CITY OF BLOOMINGTON  
BOARD OF ZONING APPEALS  
May 26, 2016 at 5:30 p.m.

- V-9-16 **Three Guys Funding, LLC**  
1909 W. 3<sup>rd</sup> St.  
Request: Variance from karst conservancy easement standards to allow development within required easement area and within the karst feature.  
Case Manager: Jackie Scanlan

**BLOOMINGTON BOARD OF ZONING APPEALS**  
**STAFF REPORT**  
**LOCATION: 1909 W. 3<sup>rd</sup> Street**

**CASE #: V-9-16**  
**DATE: May 26, 2016**

title: OVERALL SITE PLAN

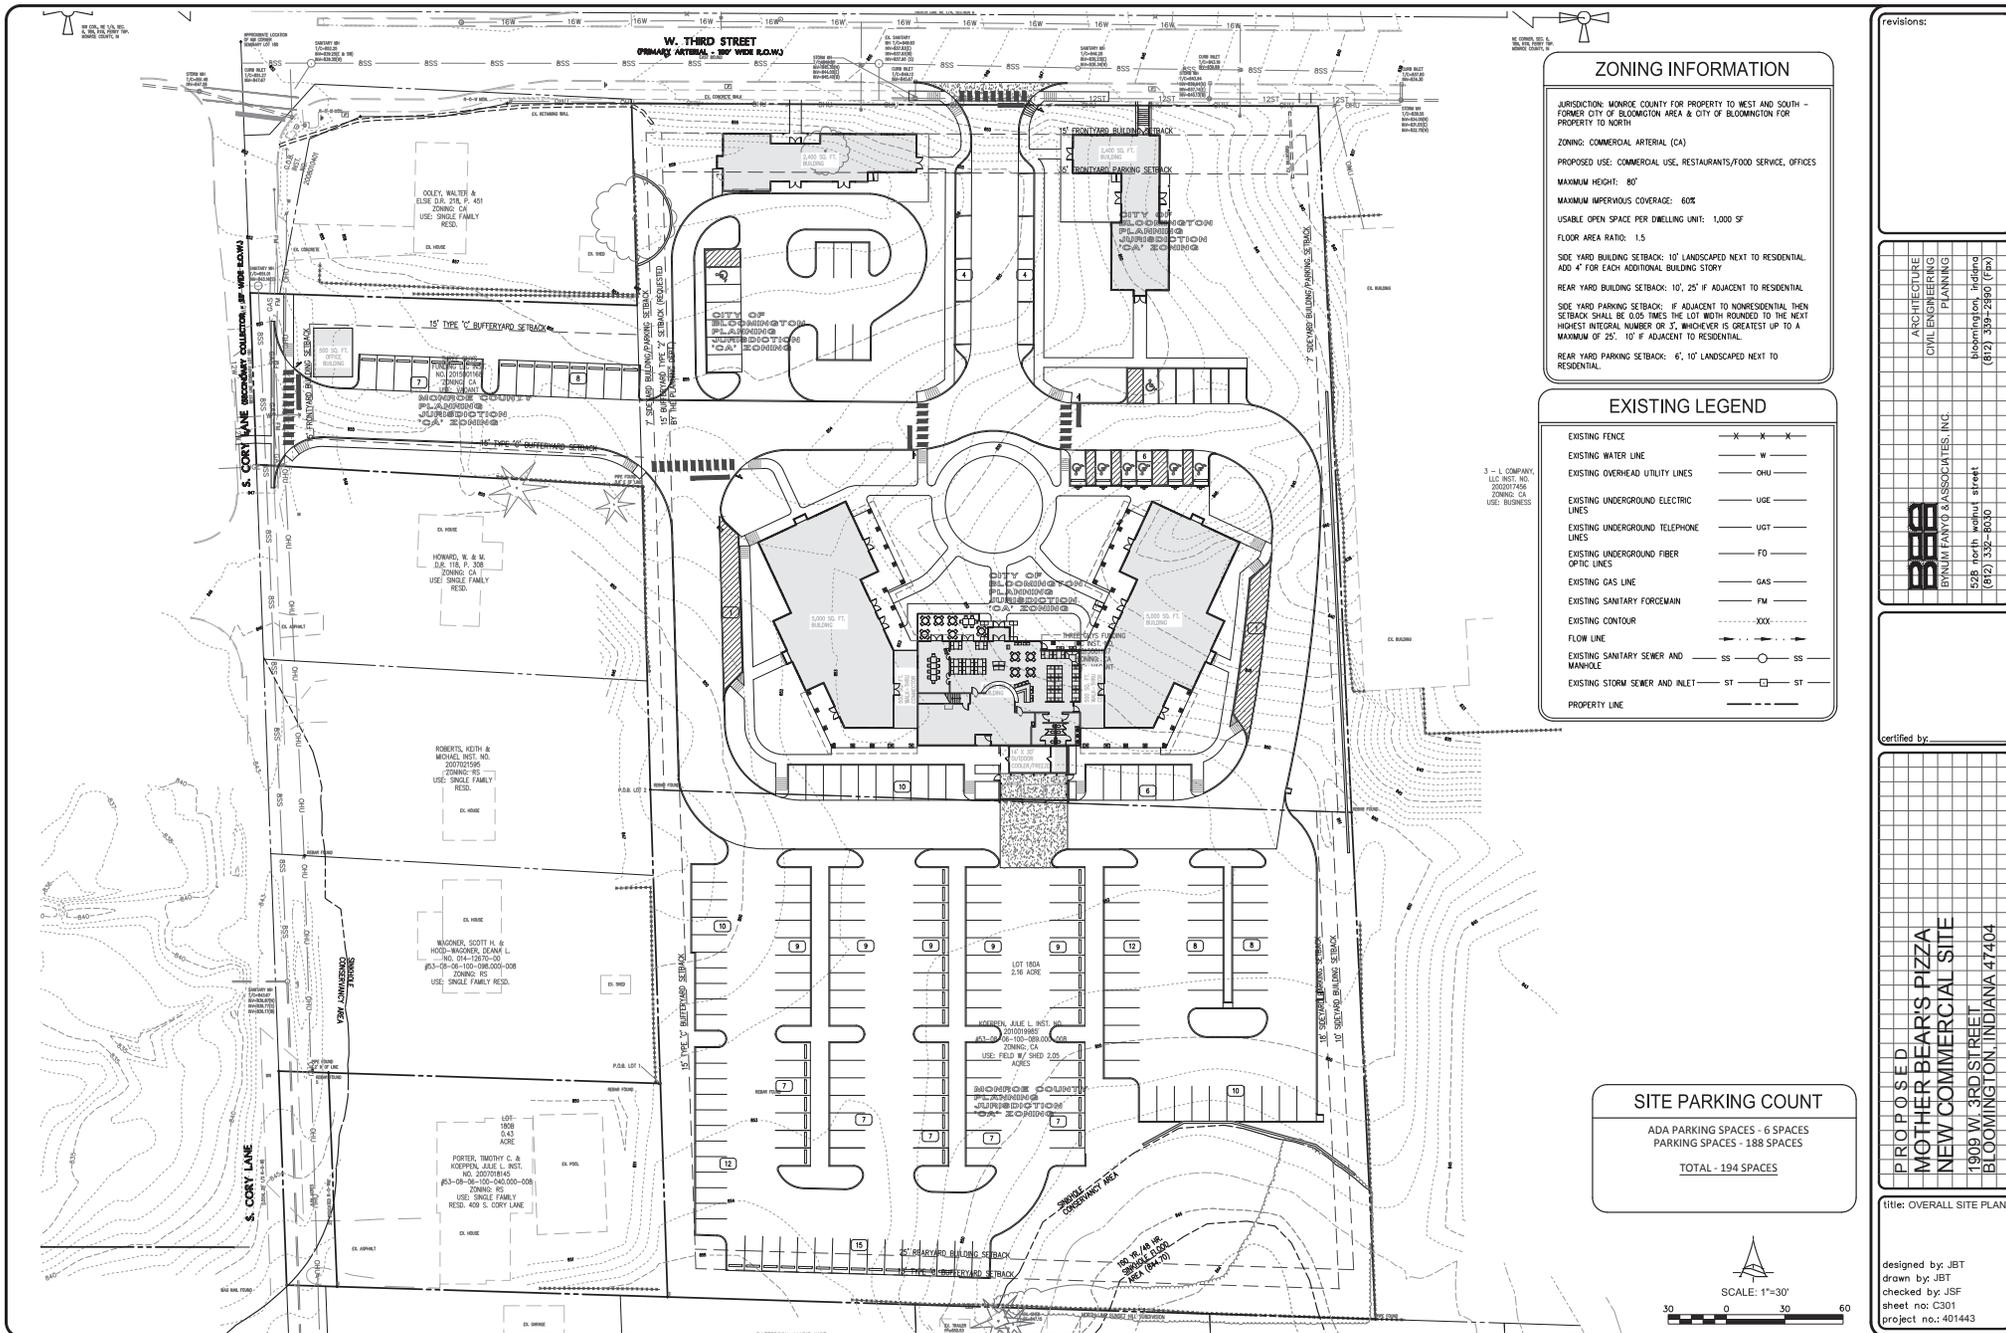
The karst feature is defined as the last closed contour of the sinkhole and is about 852 ft. above sea level. A twenty five (25) foot KCE buffer and a 10 foot building setback, as described in the BMC, would be measured horizontally from there. The EC believes that these protective regulations should be followed, and no variance to skirt them should be granted.

Our client's property lies completely out of all of these protection zones. The lowest closed contour on this property is 848. The last closed contour of the karst feature is 852. The site grading plan was developed with the cooperation of the City and County drainage engineers and significantly less storm water from our building or parking areas will drain to this karst feature. With the exception of our entry drive to Cory Lane all storm water will be directed north and east eliminating the impact on this feature.

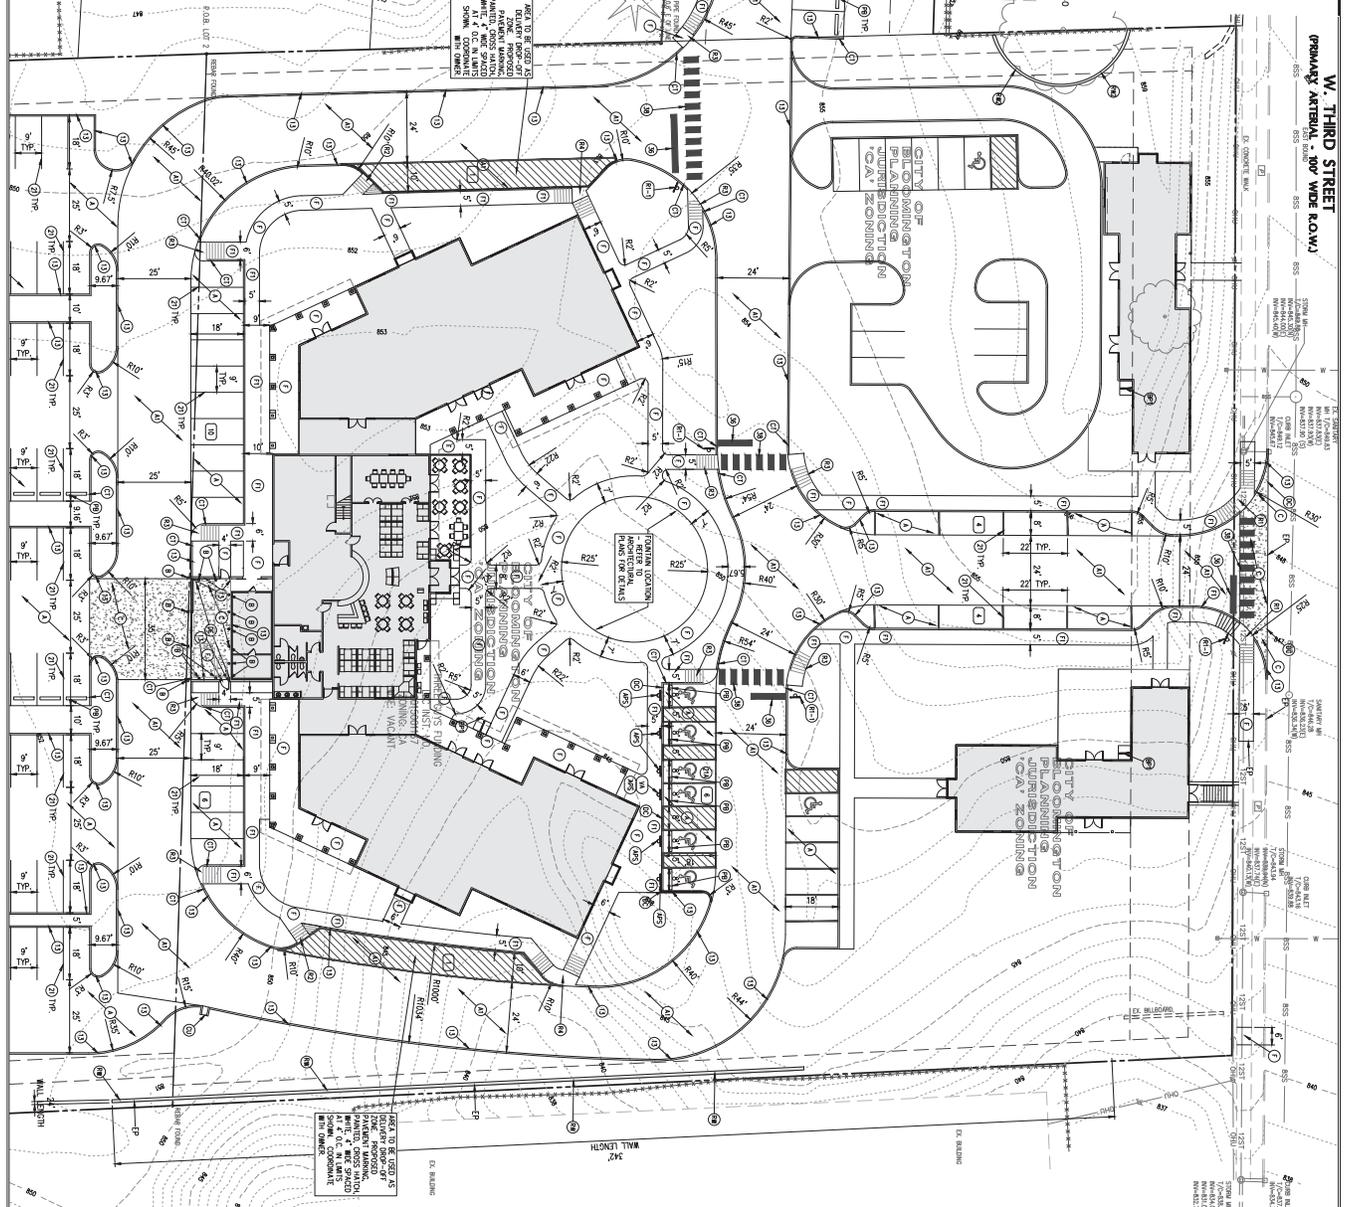
The EC does not believe that the changes made to the Site Plan that are related to the sinkhole are significant, and is still opposed to the variance of the 20.05.042 EN-05 [Environmental Standards; Karst Geology].

The report stated that it is likely that erosion and siltation during construction could create a large impact on the sinkhole and the groundwater regime. However, the report is incorrect to say that no excavation will occur inside the 852 foot contour line defining the sinkhole. The plan shows that the edge of the building will be touching that contour line (it is impossible in the real world to construct a building without going outside the line drawn on a plan.) Also, the street, sidewalk, parking, grading, and fill placement will all occur within the sinkhole.
